VESTEL ELEKTRONİK A.Ş.	CHANGE BULLETIN (TCN)	CHANGE NO: 70 REF NO : UMB 1256
-----------------------------------	----------------------------------	--

AFFECTED MODELS: ALL NTSC-AMERICAN MODELS WITH 11AK19 CHASSIS INCLUDING V-CHIP CONTROLLER IC.

REASONS OF CHANGE: WRITE PROTECTION CONTROL OF IC502 (EEPROM).

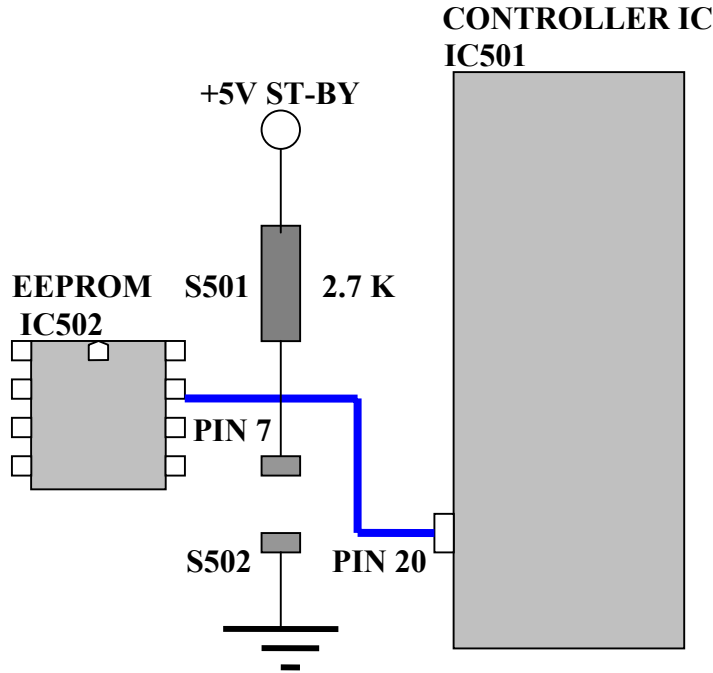
NOTE 1: The cable (6 cm.) must be connected between the Pin 20 of IC501 and Pin 7 of IC502 under the PCB.

NO	PCB CODE	VESTEL CODE	COMPONENT NAME	POSITION NUMBER	QUANTITY
1	11AK19	30001734	JUMPER SMD 0805	S502	1

NO	PCB CODE	VESTEL CODE	COMPONENT NAME	POSITION NUMBER	QUANTITY
1	11AK19	30000631	RES SMD 1/10W 2K7 J 0805	S501	1
2	11AK19	30009834	CABLE BLUE 0.6MM	NOTE 1	1
